Austar Coal Mine Pty Ltd

# **Proposed Stage 3 Modification Response to Submissions**

Project Director:	Peter Jamieson		
Project Manager:	Catherine Pepper		
Report No.	2274/R75/Final	Date:	November 2011

FIGURE 3.1

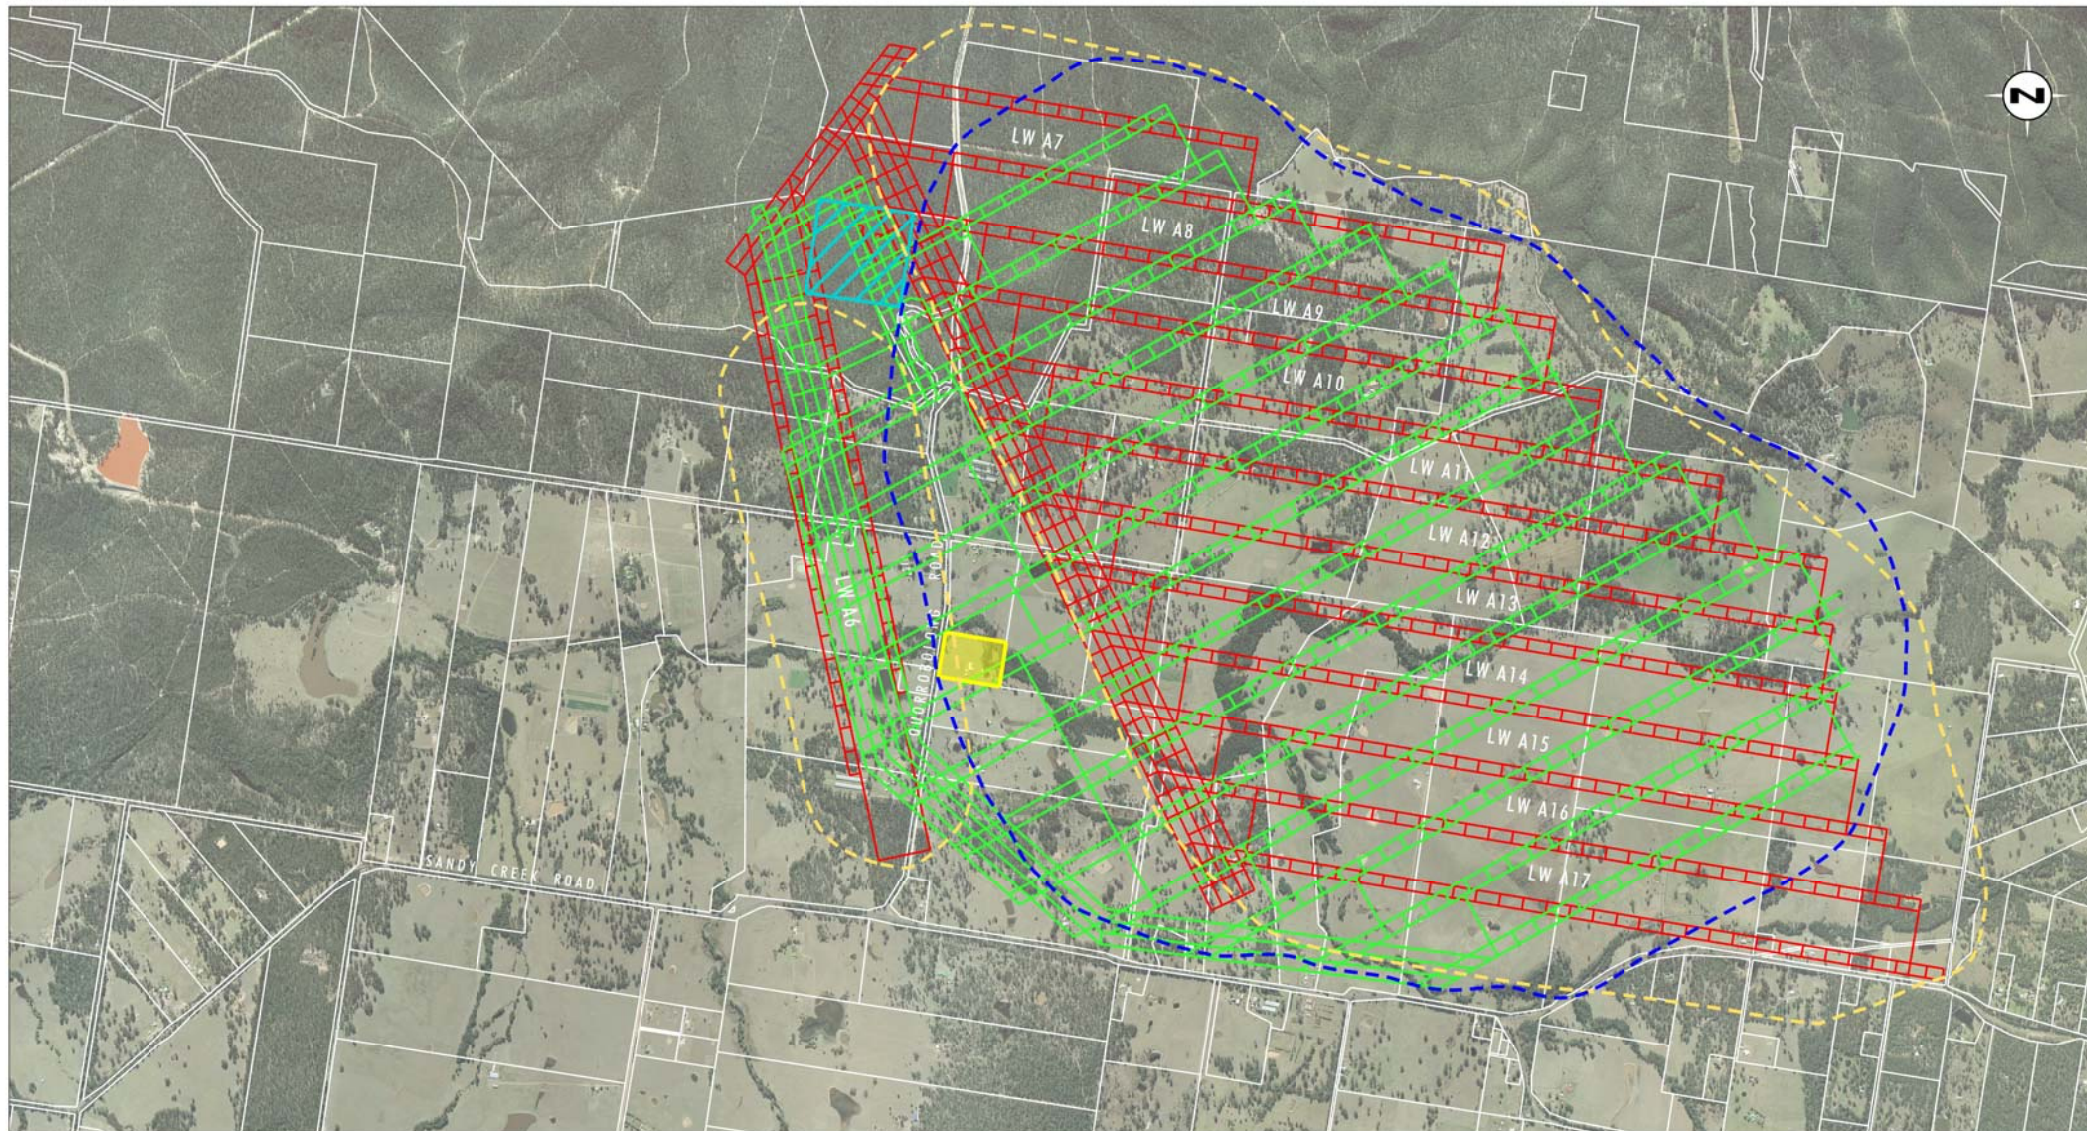
1. The proposal will increase the impact from Stage Three as previously approved, as our entire property, including our home, is now included within the subsidence envelope; whereas previously, the subsidence envelope cut across the front third of our property.

As discussed in the EA, the overall area of surface impact has reduced by 140 hectares, as a result of the proposed Stage 3 Modification mine plan, however the location of surface impact has altered in some areas. Surface impacts are proposed to be decreased in the west of the approved Stage 3 area via the removal of Longwall A6, decreased in the south-east and north-west by reorientation of longwall panels, and increased for a section of land between the approved Longwall A6 and the western extent of approved Longwalls A7 to A17. The O'Dwyer and Quinn property is located within the section of land between the approved Longwall A6 and Longwalls A7 to A17 as shown in **Figure 3.1**. The modelled change in subsidence impact to the O'Dwyer and Quinn residence from the Stage 3 mine plan as approved to the proposed Stage 3 Modification is provided in **Table 3.1**.
